REVIEW OF GEOLOGIC AND HYDROLOGIC ISSUES  
RELATED TO WASTE ISOLATION IN  
COLUMBIA RIVER BASALTS

TECHNICAL REPORT

August, 1981

Office of National Waste Terminal Storage Integration  
Battelle Memorial Institute  
Columbus, Ohio 43201

FIGURE 4. CONCEPTUAL MODEL OF THE REGIONAL GROUND-WATER FLOW IN THE COLUMBIA RIVER BASALTS

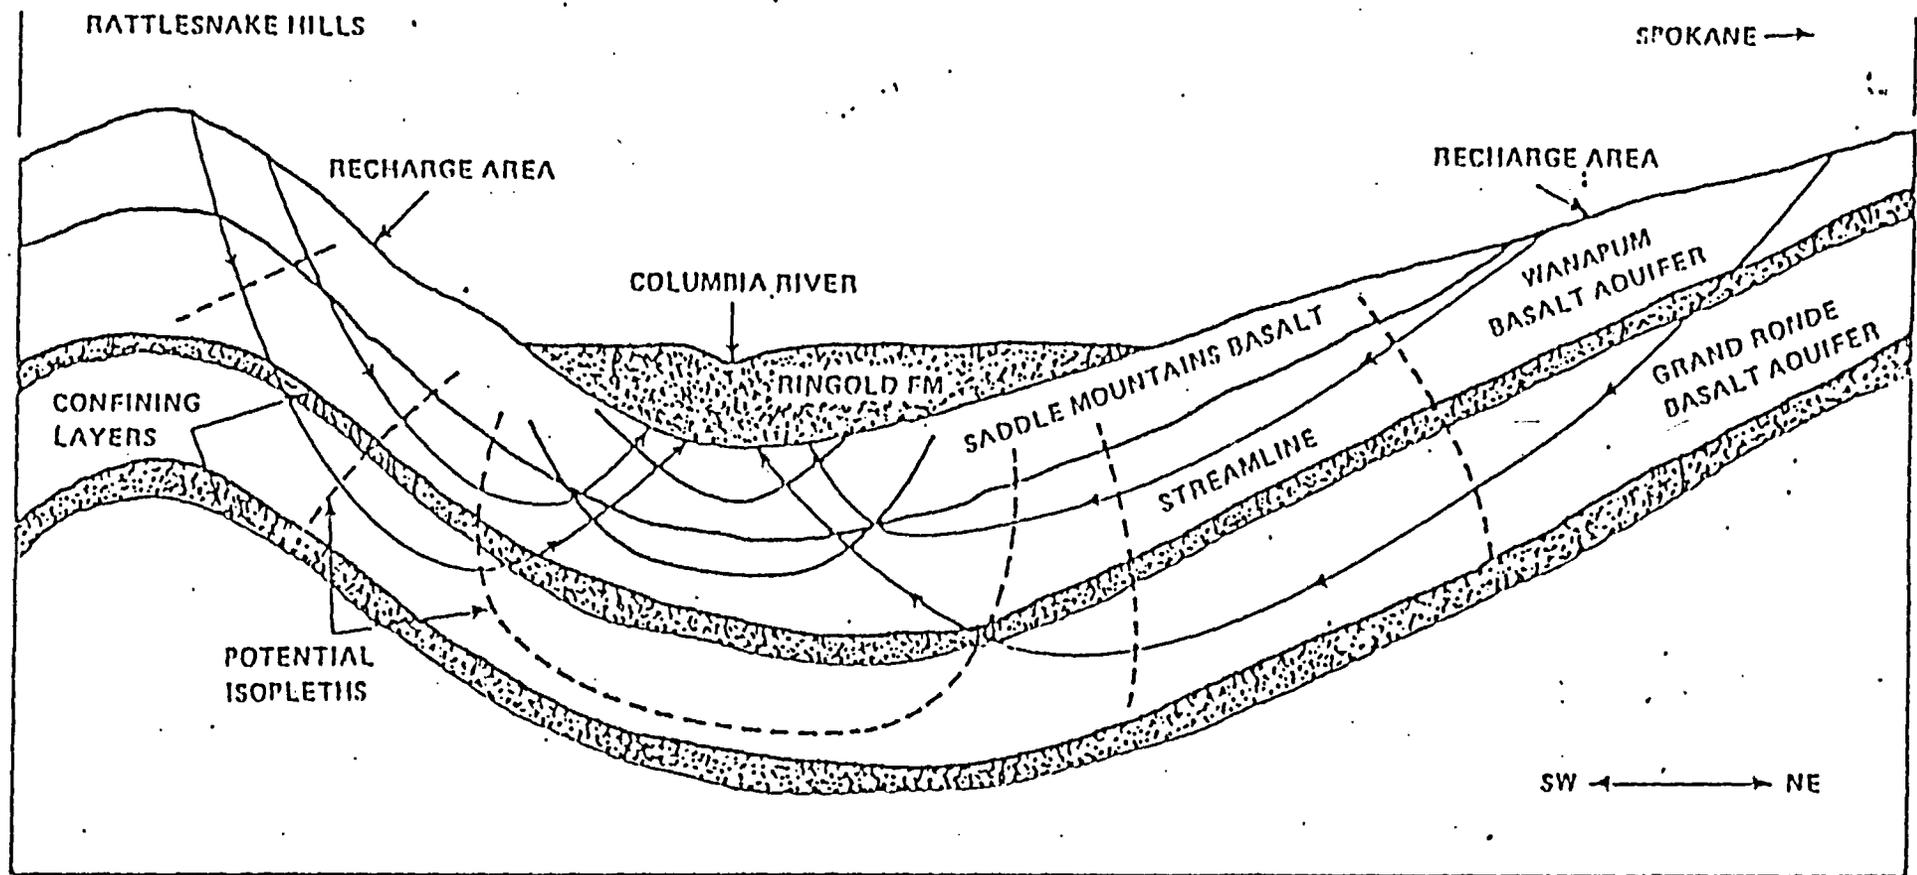
Geochemical stratification of the waters in the basalt sequence has been presented as support for the argument that the flow in the Grande Ronde is separated from that of the overlying Saddle Mountains and Wanapum basalts. However, this argument can only be supported by showing that the simple conceptual flow model of the basalt sequence (Figure 4) is not compatible with the geochemical stratification.

Geochemical models such as EQ3/EQ6 and FASTPATH should be used to determine whether chemical differences are compatible with the existing interpretation of the ground-water flow system. Achievement of agreement among geochemical data, geochemical modeling, and ground-water flow modeling would provide strong evidence that the predicted ground-water flow is correct. Also, if temperature data were shown to be compatible with geochemistry and flow, there would be little doubt of the adequacy of the understanding of ground-water flow through the basalt sequence of the Columbia River Plateau. Currently enough data exist to begin geochemical modeling in the Saddle Mountains and Wanapum; and by the end of fiscal 1981 enough data will be available to begin preliminary geochemical modeling of the Grande Ronde basalts.

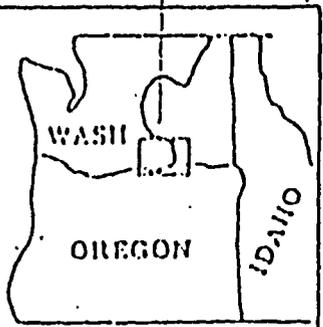
A2.1. The HIR makes the case that the most likely discharge area for the Columbia River basalts is the Lake Wallula portion of the Columbia River (Region II, enclosed Figure 1). The reason for the espousal of the Lake Wallula discharge area appears to be the apparent lack of hydraulic interconnection between the interbed aquifers beneath the Columbia River in the vicinity of the Hanford Site (HIR II-147; III-199(b);

Figure 1. Relationship between expandability and temperature for illite from well "E" of Perry and Hower (1970).

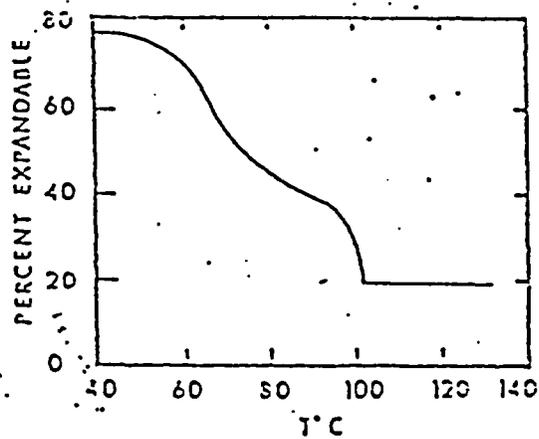
B6.3. In the RIR, Rockwell states that the ambient temperature is approximately 65 degrees in the Grande Ronde and fracture fillings of clays are predominately smectite, indicating they are the stable phase in the basalt environment. This comment represents a defensive attitude for the site that we do not understand. We have raised here what might be a serious issue that has obviously not been addressed in any detail by RHO, and, in addition, with no apparent commitment to do so. These clays are indeed stable for all practical purposes at the above cited temperature, but what happens under repository temperatures? Included here is a figure (Figure 2) from Eberl and Hower (1976) that shows the % expandable clays at 60 degrees C is about 75% (that is, at 60 degrees the mixed layer clay is initially 75% smectite and 25% illite). At 100 degrees C, the mixed layer is 20% smectite and 80% illite. In the Gulf Coast, this reaction zone coincides with an excess fluid pressure zone which is the result of interlayer water being converted to free water in a low permeability environment. Such excess pressures are not anticipated in a fractured medium such as basalt as a result of this mechanism, but certainly free water and permeability increase are. If the solid volume decrease results only in a porosity increase (that is noninterconnected openings in the fractures), excess pressures can develop if the free water is subject to thermal expansion. Contrary to the RIR, this does not require vaporization (see Domenico and Palciauskas, 1979).

B6.4. Considerably more information is required in terms of the type of smectite in these basalts and a laboratory confirmation of reacting temperatures, volume changes, and interlayer waters made available. Does the nontronite and beidellite, being dioctahedral like montmorillonite, behave similarly in response to temperature rises? Is it possible to drive off interlayer water by heating alone without actually completing the smectite/illite reaction? These questions cannot be dismissed in view of the fact that there exists here a possible site failure mechanism that thus far has not been addressed nor even recognized in any detail by RHO.
